Technical note:

Development of Bristol Airport to Accommodate 12 Million Passengers Per Annum: Response to Comments on Landscape

Technical note to accompany the photomontage visualisation of A38 works undertaken as part of proposed 12 mppa development

Photomontage visualisation showing baseline situation and proposed 12 mppa A38 highways works in view south-west from the junction of A38 and Downside Road

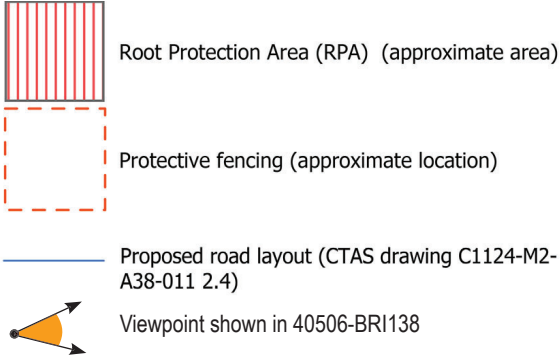
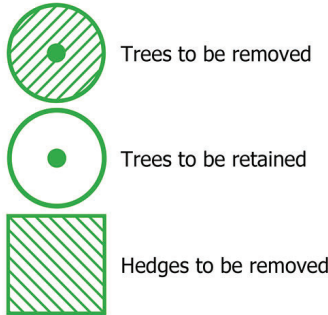
NSC raises a concern regarding the impacts of the proposed changes to the main airport entrance and the A38/Downside Road junction. NSC states that it assesses that “*local impacts on landscape character*” will see some “*moderate if not significant change*” and that officers require “*some assurance than an effective landscape scheme can be re-established ...*”.

During a subsequent site visit, planning officers at NSC requested that a suitable visualisation be provided to illustrate the proposed highway works and the impact of the associated loss of vegetation.

The view of the operational proposed highways works has removed the ancillary highways elements such as traffic lights and signage. This has been undertaken to minimise visual clutter and allow a full understanding of the proposed landscape and visual changes. The removal of a number of trees and shrubs close to the footways along the A38 and Downside Road to accommodate the proposed widening of the A38 and revised junction will allow receptors' views to extend further into the woodland in the former quarry. Nevertheless, as confirmed by the aerial plan showing the vegetation to be removed, a large proportion of the existing vegetation will be retained. The retained vegetation will coalesce to continue to provide screening in combination with the vegetation in the gardens of High Lands and Greenacre and along the closest section of the Airport boundary which will be unchanged in comparison with the baseline. The result will be that the carparking and closest existing and proposed built components at the airport, including those proposed under the proposed development, will not be visible even in winter conditions.

The loss of the closest vegetation on the edge of the woodland will alter the composition of the horizon, reducing its height, although the prominent coniferous tree will be retained. At the beginning of the operation period the boundary fencing will be moderately visually prominent, and consideration will need to be given to the specification of a recessive colour scheme to reduce its visual role until the proposed native hedgerow and native woodland edge shrub planting on the slope becomes established. The northern-most of the extra heavy standard trees (Norway maples) to be planted in the eastern boundary of the northern carpark will be visible at the left hand end of the vegetated section of the view (above the cars on the visualisation).

The photomontage visualisation illustrates the most open operation period views that could be available to the residential visual receptors in the eastern Lulsgate Bottom sub-group. Review of the change to the proposed view confirms that the assessment of a low magnitude of change in Table 9G.1 is correct. The fundamental composition of the view does not alter, with a limited adjustment to the relative proportions of carriageway surfacing and vegetation cover. The key consideration is that, even in winter, the temporary reduction in the amount of mature vegetation cover in the view will not result in visual receptors gaining filtered views of carparking or any existing or proposed built elements at the airport. As the proposed native hedgerow and native woodland edge planting become established and assumes a stronger visual role, the balance of the views will revert back to the baseline view and the visual role of the boundary fencing will decrease.
